Our Ref: 27485Let2

RE: INFORMATION REQUEST FOR FURTHER DETAILS NORTHSORE HAMILTON URBAN DEVELOPMENT AREA (UDA) DEVELOPMENT APPLICATION FOR MATERIAL CHANGE OF USE FOR MULTIPLE RESIDENTIAL (168 UNITS) AND SHOP AT 37B HARBOUR ROAD, HAMILTON.

This letter forms TTM's response to the traffic engineering issues noted in the Information Request issued by the ULDA dated 17 February 2012. The issues are addressed as followed:

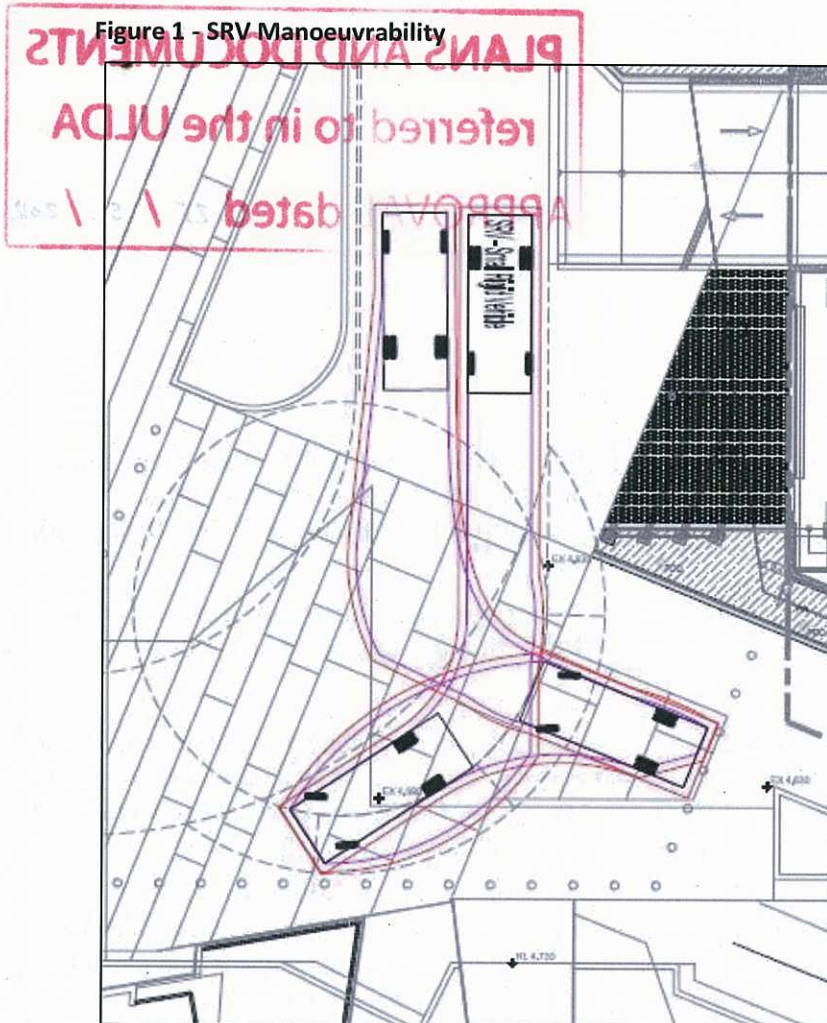
1. *A copy of the Service Management Plan and Waste Management Plan referenced by TTM in the submitted application was requested; however the response only referenced the Waste Management Plan. A copy of the Service Management Plan is required to be submitted and should address the issues raised in the Information Request.*

5. *In regards to Issue 3 of the Information Request, the response provided by TTM only refers to the potential vehicle/ pedestrian conflict which will be addressed through bollards. The issue of concern however was the impacts the whole of Portside service/loading bay outside Building 4 will have on the Building 2 drop off zone and pedestrian entry along with the pedestrian spine. We would expect the response to be driven by TTM rather than TTM commenting on Lat 27 plans. Please provide amended analysis which addresses the impact of the potential conflict.*

It is intended that the servicing requirements for Building 2 in terms of furniture deliveries, etc. will be facilitated via the service vehicle bay positioned between Buildings 2 and 4 as shown in Figure 1 below.

As shown in Figure 1, SRV's enter the bay in a reverse gear and exit in a forward gear.

Given the standard of apartments in this precinct, the turnover of tenants is expected to be minimal, hence the demand for furniture deliveries to Building 2 is expected to be infrequent. It is TTM's view that the estimated demand of 1 furniture truck per week is a reasonable expectation for Building 2.

The Portside Wharf Community Management Statement also provides the ability for the timing of tenants moving in / out of an apartment to be scheduled in a manner that does not conflict with peak traffic or pedestrian movements adjacent to the proposed loading area.

Given the restriction of vehicle size, the infrequency of deliveries and the ability to schedule the deliveries outside of peak periods, it is concluded that the proposed service vehicle area between Buildings 2 and 4 will operate in a safe and efficient manner without impacting on the vehicular and pedestrian safety and amenity within the surrounding public realm.

The service area, as shown in Figure 1 above, has been designed to allow a Small Rigid Vehicle (2t) to park clear of the internal roadway whilst also allowing the passenger set down facility to continue to operate.

PORTSIDE WEST CARPARK MASTERPLAN LEVEL 3

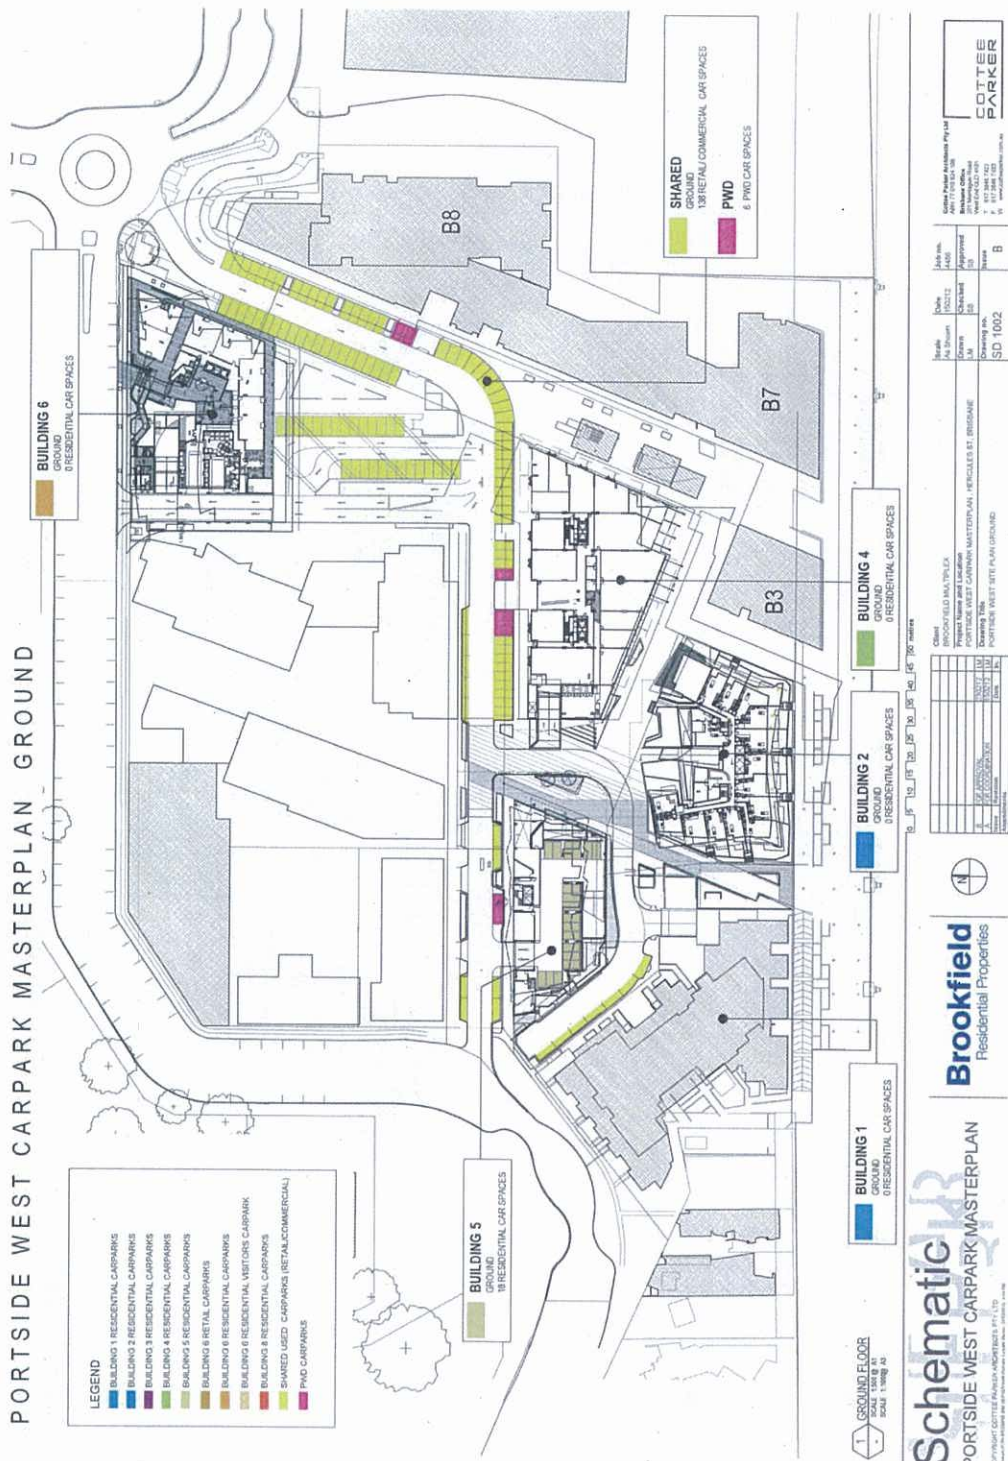
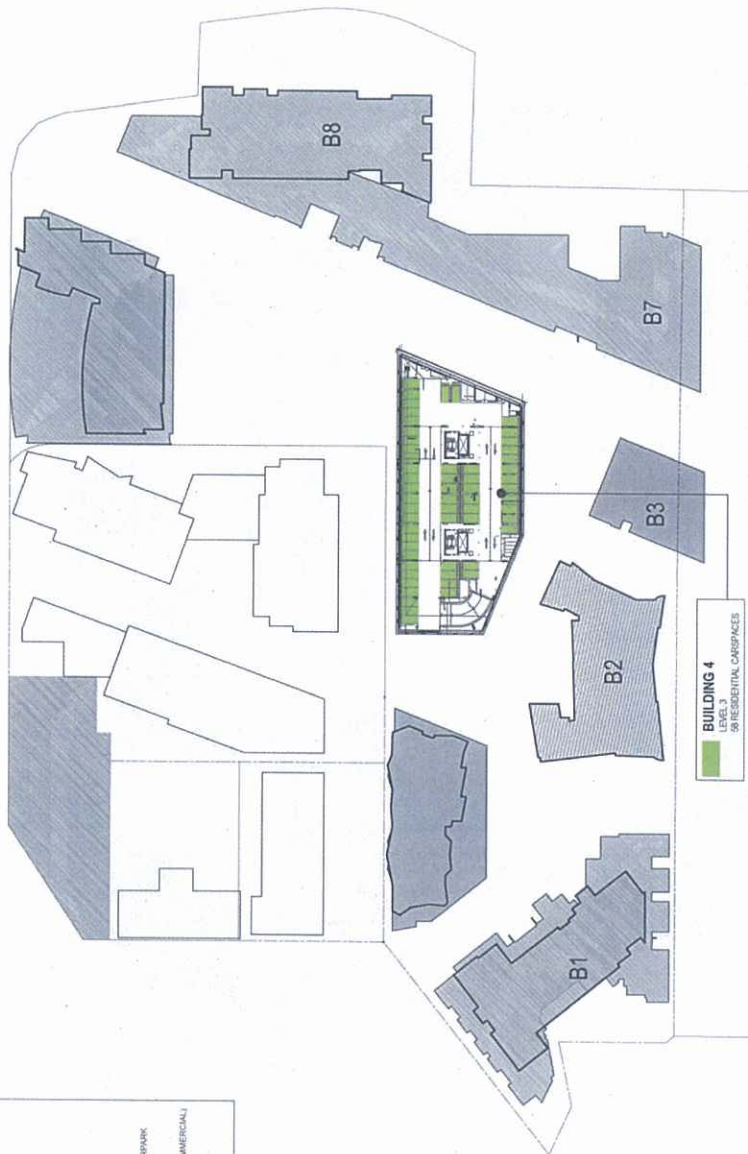
- c) *"It is considered that there is scope for dual use of the shared retail car park by visitors to the apartments." The ULDA have asked for a plan identifying the breakup of car parking across the whole Portside development to gain an understanding of how all the basement parking is assigned to each Stage and use. Provide information identifying the location and number of all car parks across the developments, including retail car parking.*

As per the ULDA's request Cottee Park have prepared plans, included in Appendix A, identifying the allocation of car parking across the wider precinct. These plans identify that 1477 car parking spaces will be ultimately provided within the precinct to facilitate the car parking demands associated with the land-uses provided for Buildings 1-8 (it is noted that other sites within the precinct will have separate parking facilities not linked to the common basement associated with Building 1 – 8). Of these, 1007 spaces will be allocated as "private" residential parking and 470 shared "public" spaces to be utilised for retail, commercial and residential visitor parking.

Notwithstanding this, it is considered that the number of PWD spaces within the shared parking areas is sufficient to cater for the various existing and proposed land-uses within the precinct. Inspection of the plans prepared by Cottey Parker included in Appendix A confirms that 16 spaces of the 470 spaces provided within the shared parking areas are allocated as PWD, which represents 3.4% of the total car parking supply within these areas.
